**UNITED STATES DEPARTMENT OF COMMERCE
National Oceanic and Atmospheric Administration
NATIONAL OCEAN SERVICE**

Re. License No.: 32-00426-02
Document No.: 03005594
Control No.: 142793

We are responding to your email dated Monday, 15 December 2008, with the subject "Department of Commerce, Request for Additional Information Concerning Application for a License Amendment."

The Center for Coastal Fisheries and Habitat Research submits the information below, in accordance with the requests of your email to facilitate your efforts to amend our Nuclear Regulatory Commission license to a "Terminated" status for license number 32-00426-02.

Ecology Wing Room 112 Characterization Areas

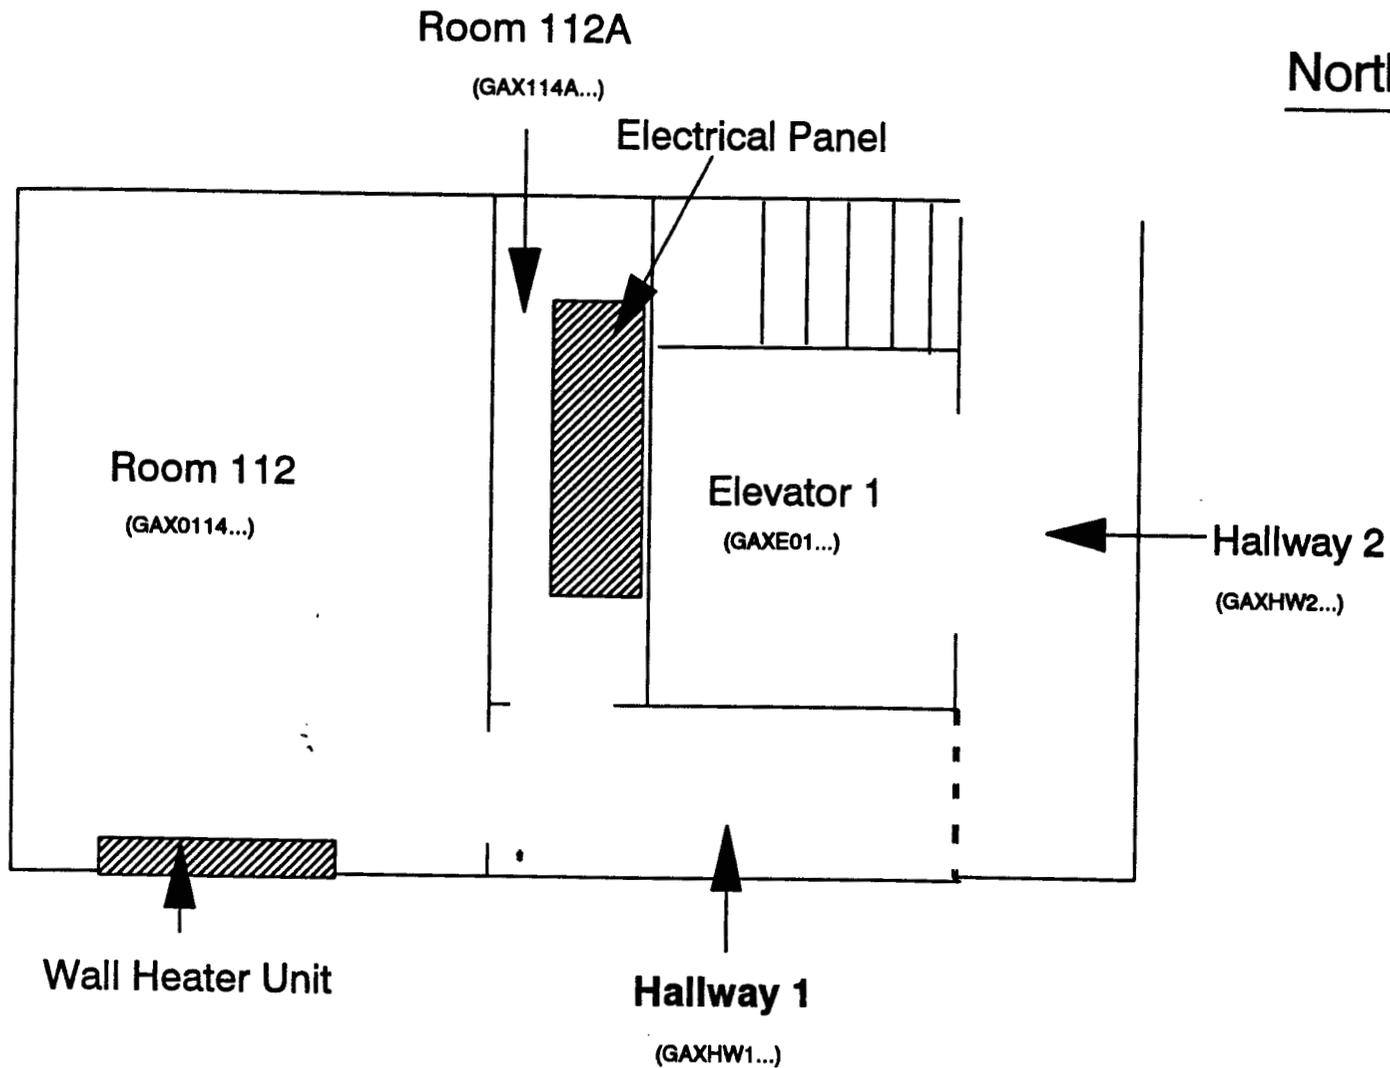
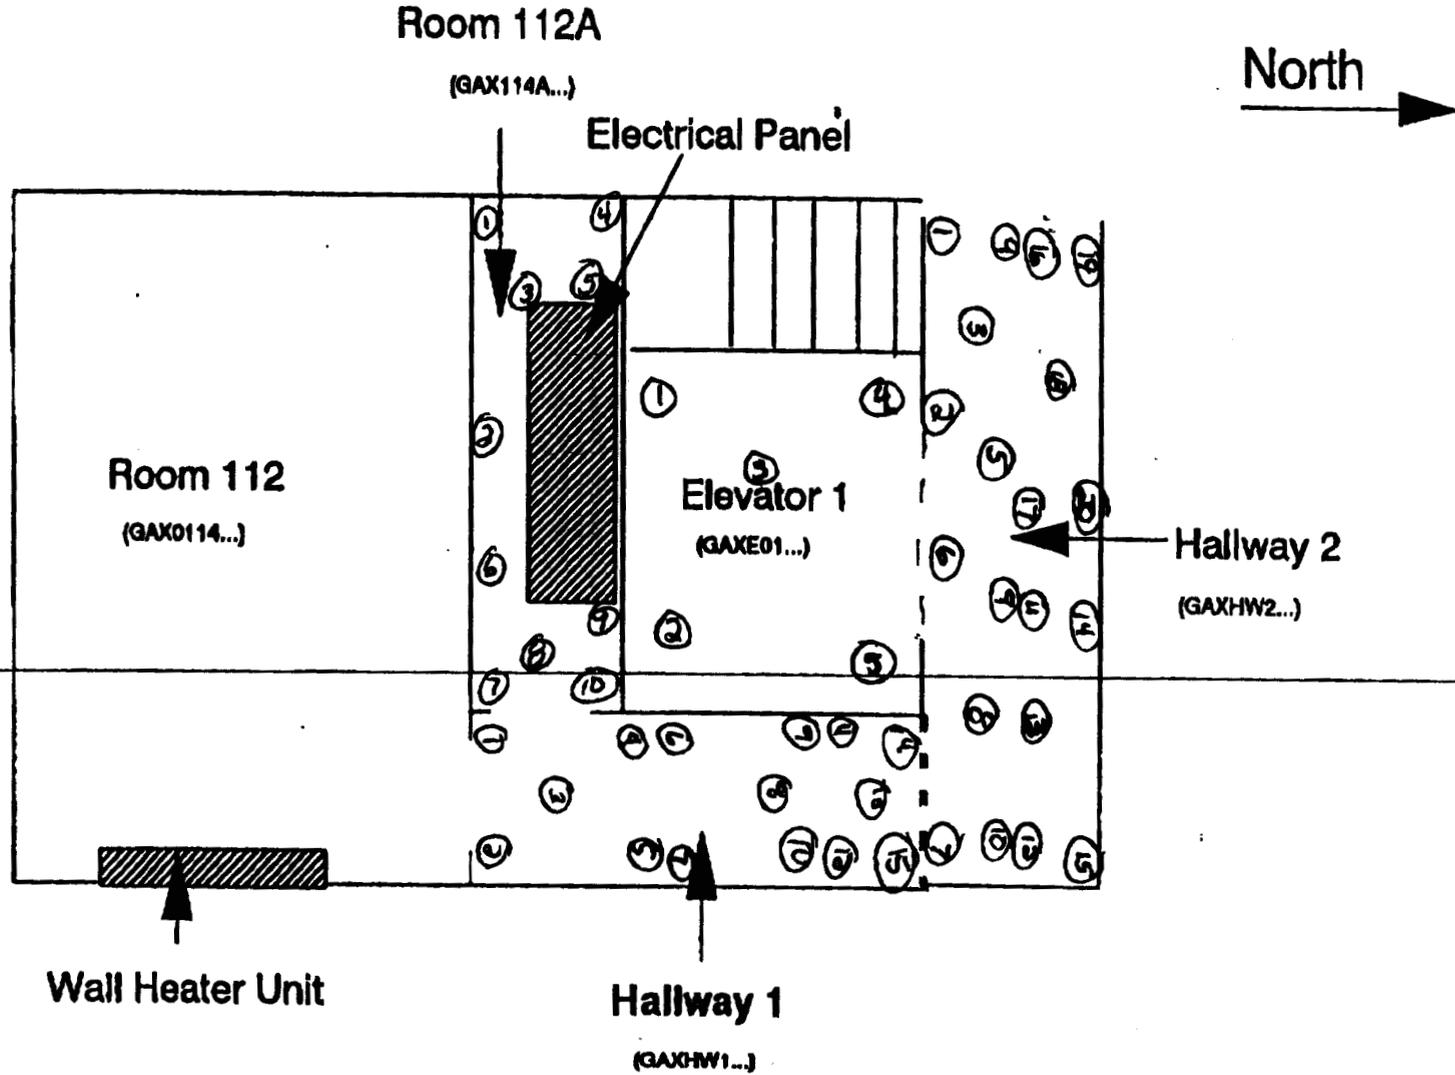
There is a small spot in the hall that gave a reading of 31,590dpm/100cm², about twice the acceptable level of unremovable contamination. This spot is less than 2 inches across, (i.e., is completely covered by the GM pancake detector), and has no removable activity. It is located just outside the door of room 112, near the wall. The SEG team said they did not have time to remove it and stay within the agreed time to complete their contract (which specified only the floor of room 112). Since this spot is in a hall that is used only for access to room 112, and furthermore, is not in a heavily trafficked portion of the floor, I'm wondering if we could allow it to remain? If not, what are the guidelines for removing it ourselves?

Fig 172

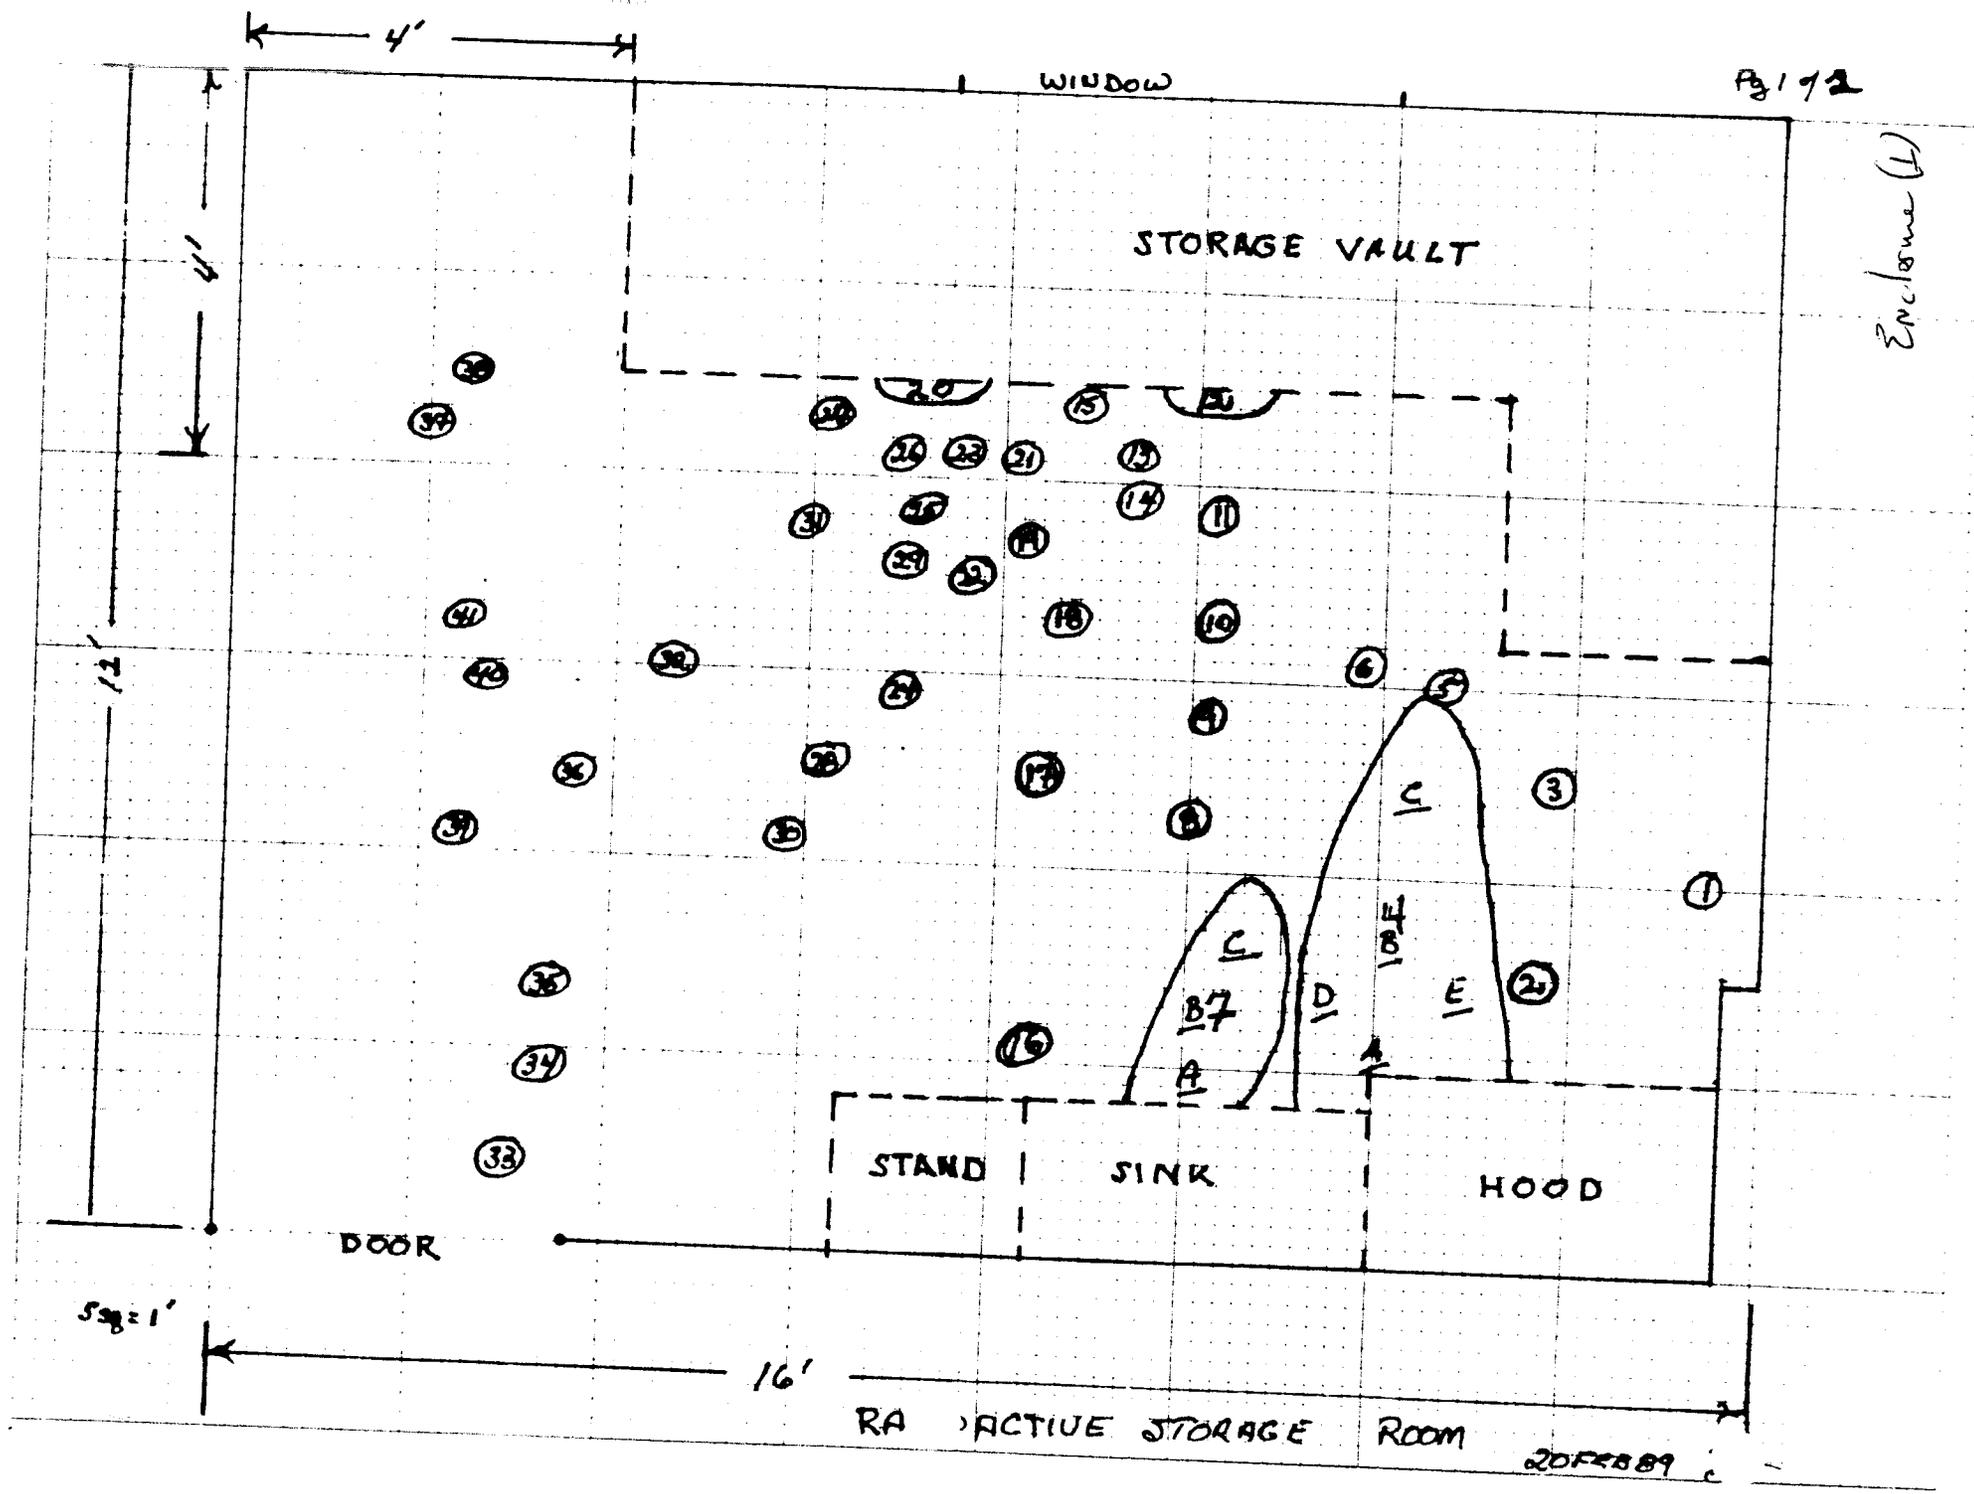
Paragraph 1 Request: In your letter dated December 5, 2008, you submitted a letter dated February 28, 1988, which showed the surveys for the room where the isotope vault was previously located. Since this area does not appear to meet ALARA criteria, please submit updated surveys or describe the location within the surveys already submitted as part of your "Inspection and Decommissioning Survey", dated October 5, 2008.

Enclosed is a drawing of the radioactive spots on the floor of the room where the isotope vault was previously located. Also, the readings obtained with a GSM-10 survey meter are included. As we discussed on the phone, I have secured the room and will wait until I hear from you to proceed with the decontamination procedure.

Response: The areas mentioned were included in our Inspection and Decommissioning Survey of October 5, 2008. However, we have had several renovation projects in the years since then after the rooms were surveyed and cleared. Some of these spaces are now being used as office spaces. Enclosure (1) of this letter is the same as enclosure (7) of our December 5, 2008 letter.
